Response to NRC's ltr dtd 02/07/78  
...Furnishing addl info on the analysis of the  
Steam Generator Subcompartment Pressure Response...  
Notorized 02/27/78...

Donald C. Cook Nuclear Plant Units 1 & 2  
Docket Nos. 50-315 and 50-316  
DPR Nos. 58 and 74  
Steam Generator Subcompartment Pressure Response Analysis

In his letter dated February 7, 1978, Mr. Kniel of the Division of Project Management requested additional information on the above cited analysis. An item by item response to Mr. Kniel's request is enclosed herein.

FIGURE 2.4

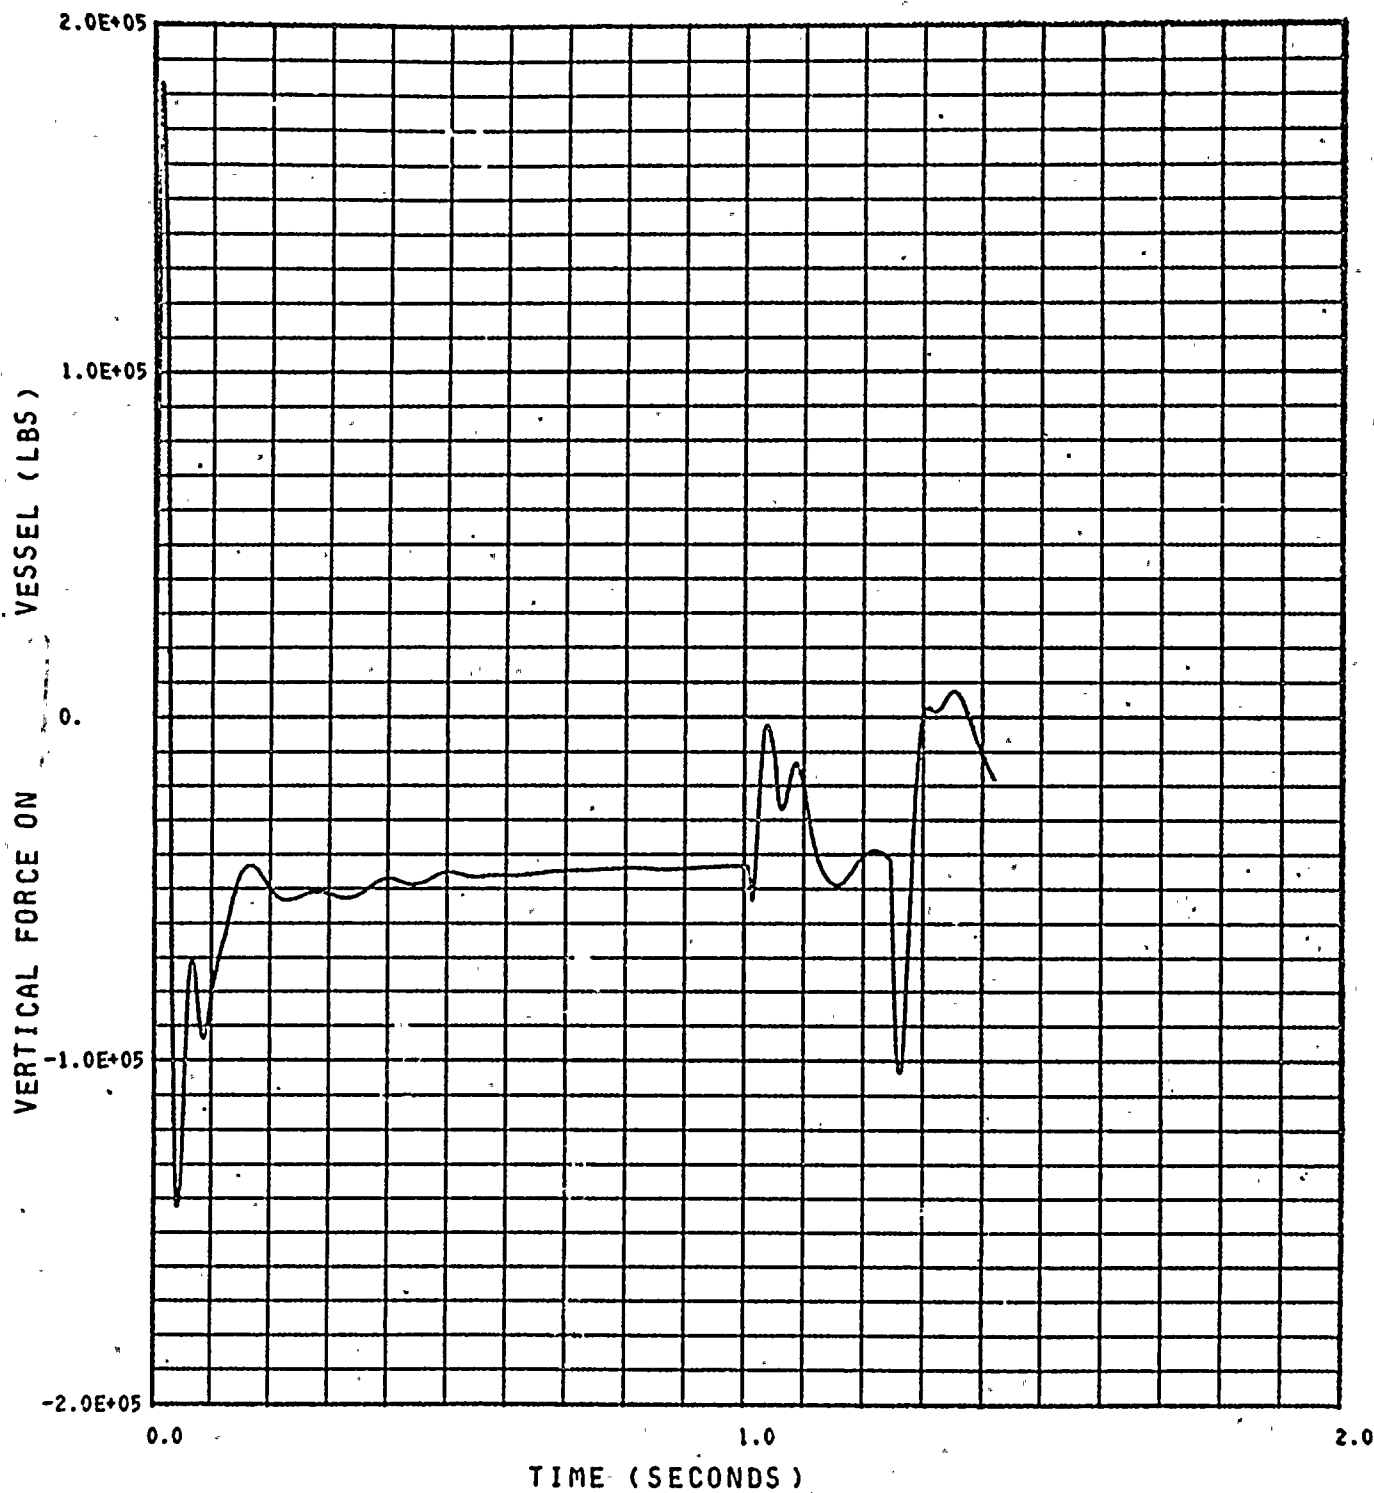
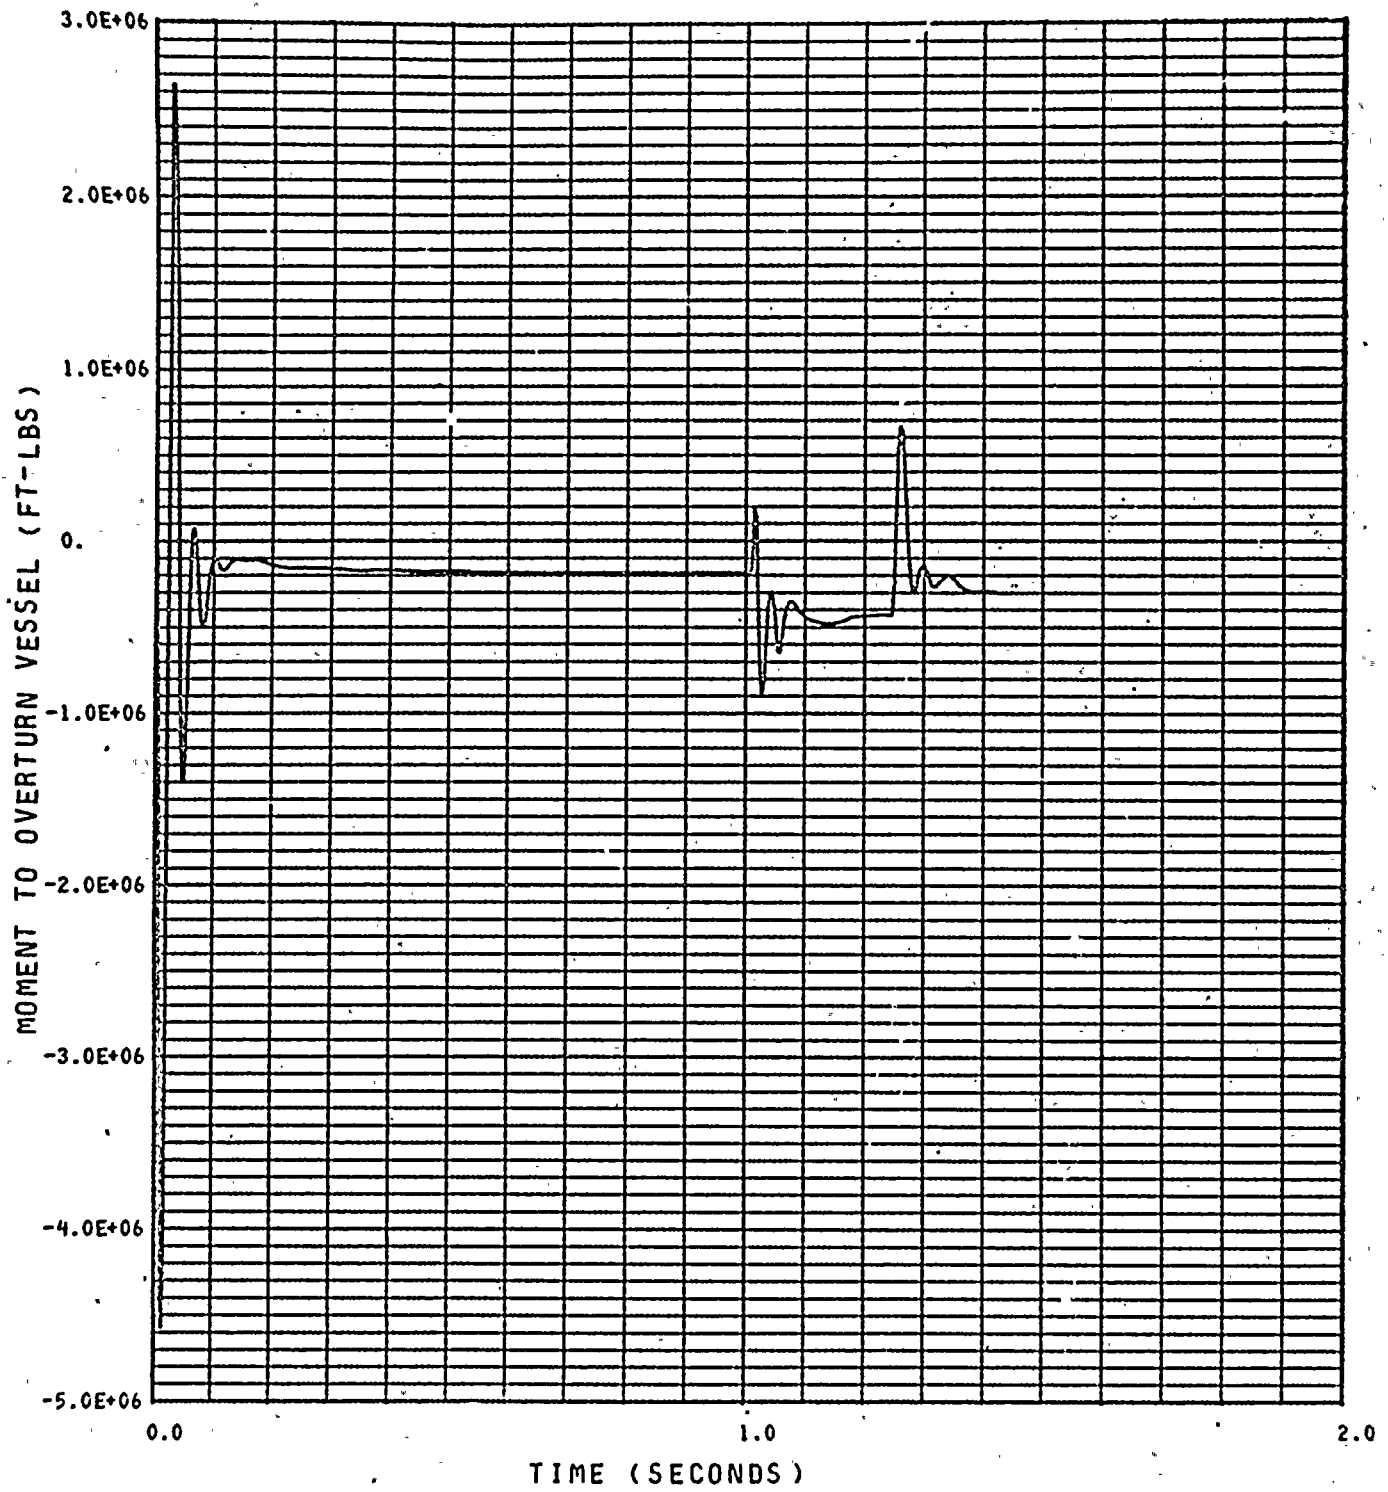
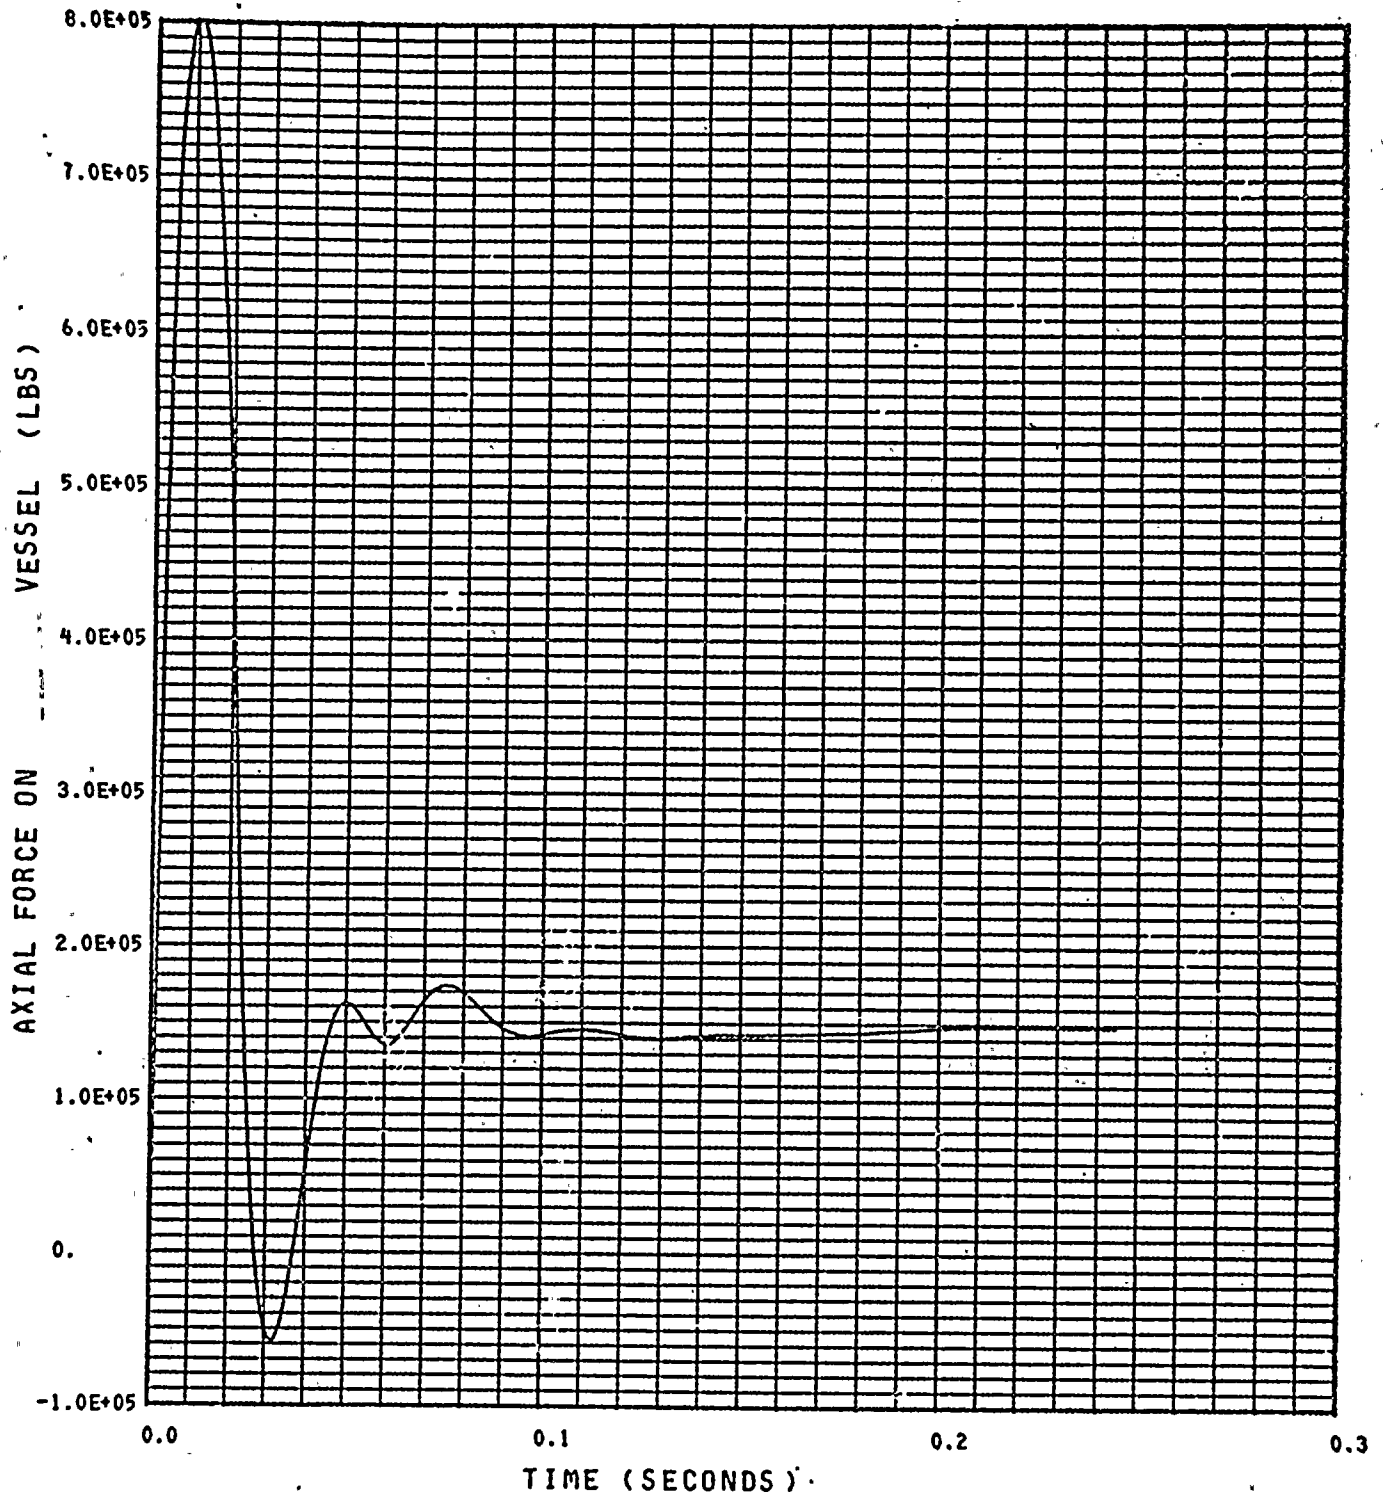
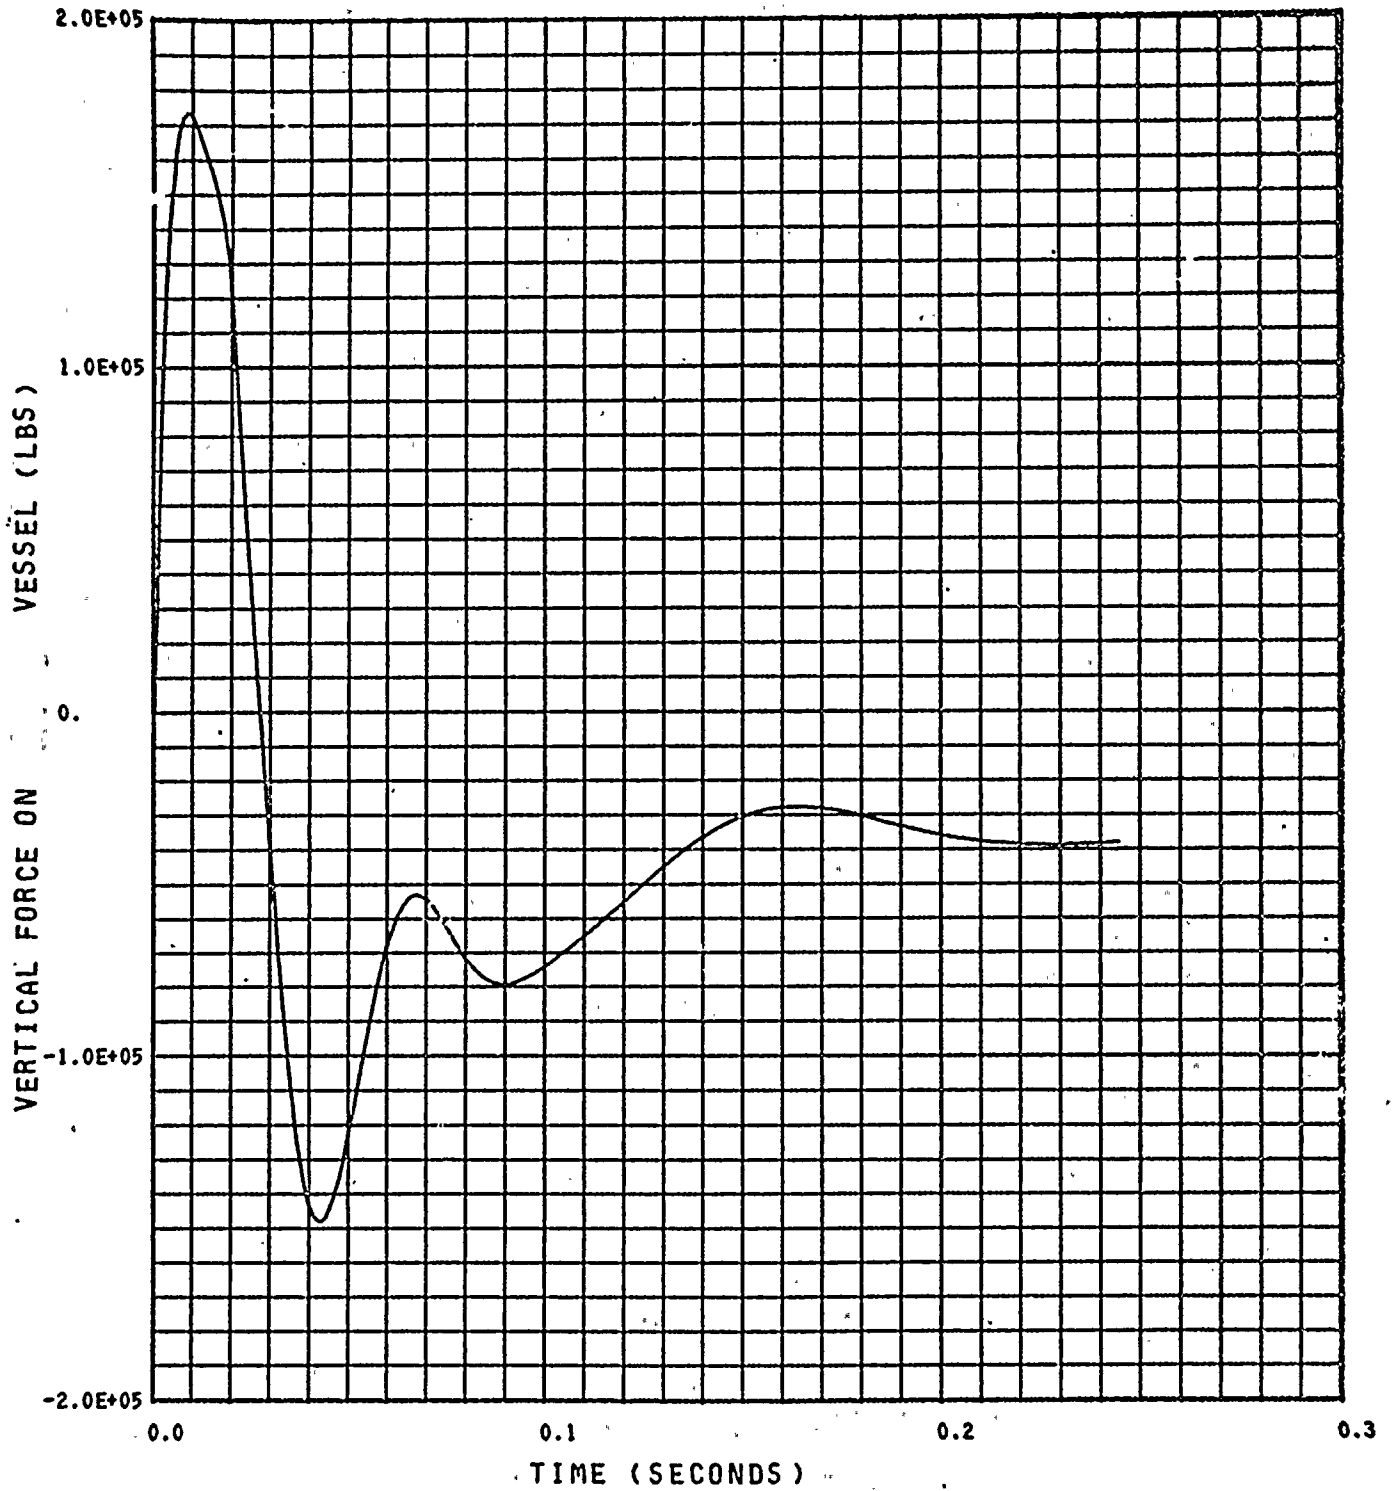
2. Provide figures which (a) identify the peak forces and moments acting upon the steam generator for each of the models used in the sensitivity studies (i.e., five, nine and seventeen node models) and (b) demonstrate that the loads transmitted to the steam generator supports are maximized by the nine node model.

- (a) Table A presents the peak steam generator loads and the time of occurrence for the five, nine and seventeen node models. Figures 2.1 through 2.9 present the horizontal (same as axial) force time history, the vertical force time history, and the moment time history for each of the three models evaluated in the nodal study.

- (b) Only the peak inertial negative moment for the five and seventeen node models were slightly higher than the peak inertial negative moment for the nine node model. The calculations of the steam generator support loads were made by combining the forces and moments without consideration of time phasing. This conservatism would result in the nine node model submitted encompassing the resultant support loads using a time phase analysis with the other 2 models. This can be seen by noting from the attached information that the peaks are quite narrow and do not occur at the same time.
